Re: Initial Submission Review: Quiktrip 4283 at High Point Site Plan and Plat
Application Number: DA-1746-42
Case Numbers: 2024-6012-00; 2024-3017-00

Initial Submission Review

SUMMARY OF KEY COMMENTS FROM ALL DEPARTMENTS

Figure 1: Map and Detail of E. 63rd Avenue in concurrent review

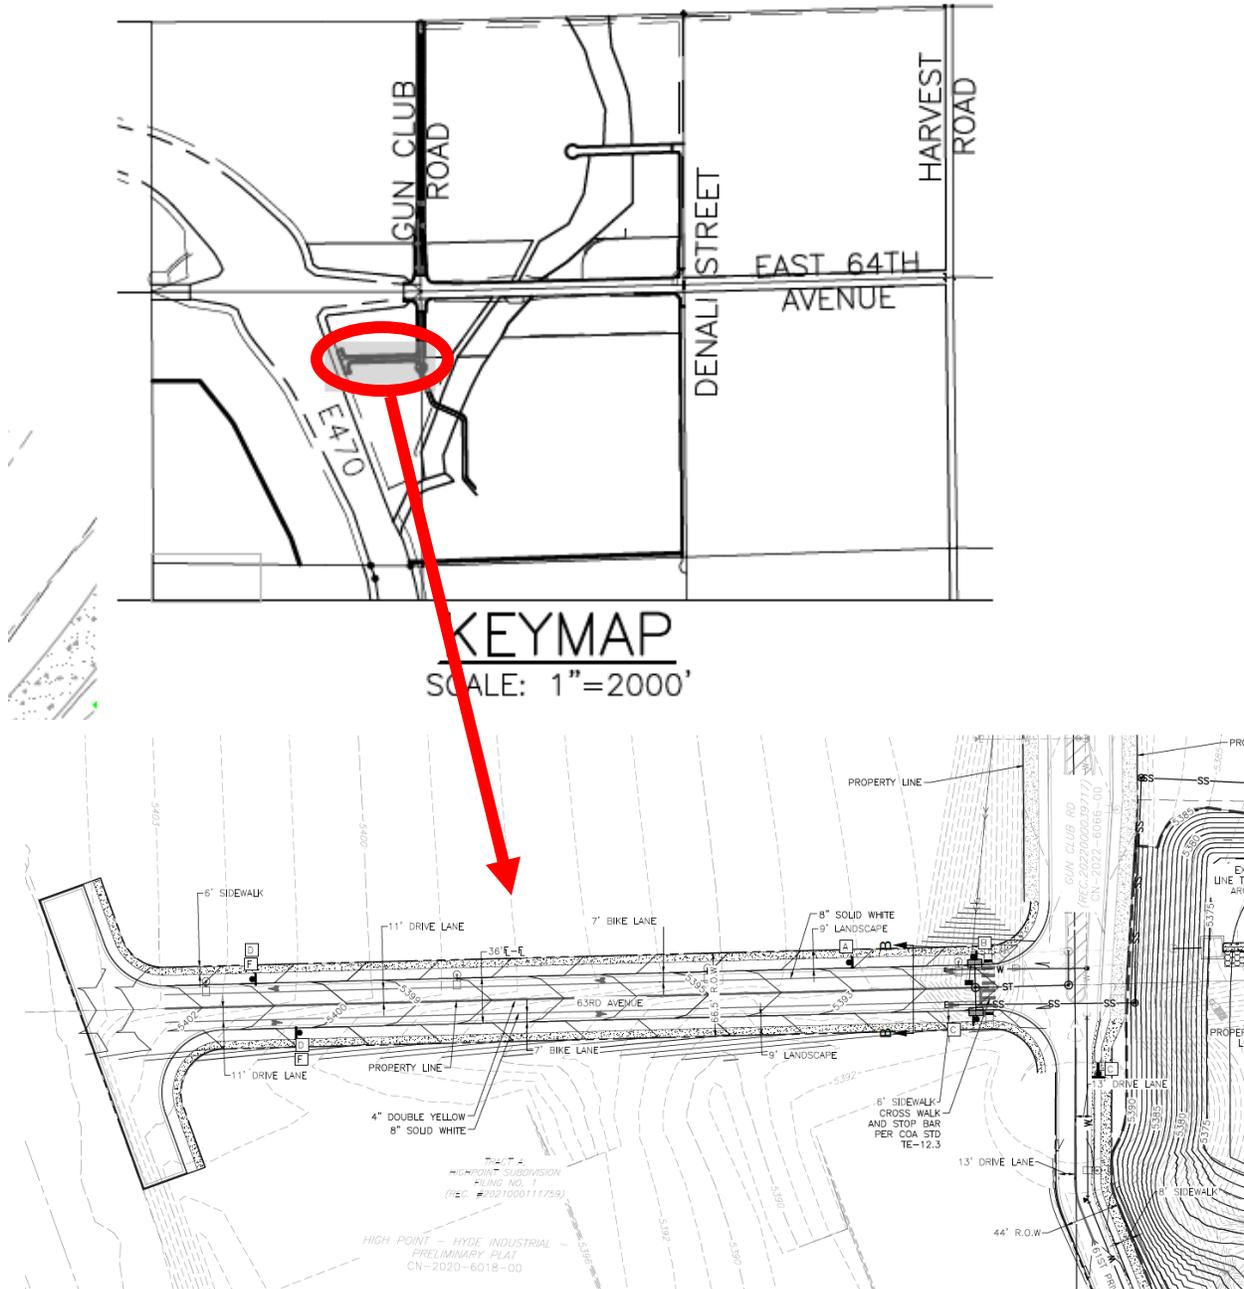
- 2H. Include E. 63rd Avenue in all application materials. A concurrent application for the adjacent property shows this ROW design and dedication. Please see Figure 1 below showing the current design in review for E. 63rd Avenue and coordinate with this site plan. If contact or any additional information is needed for the adjacent property owner, please reach out to staff.
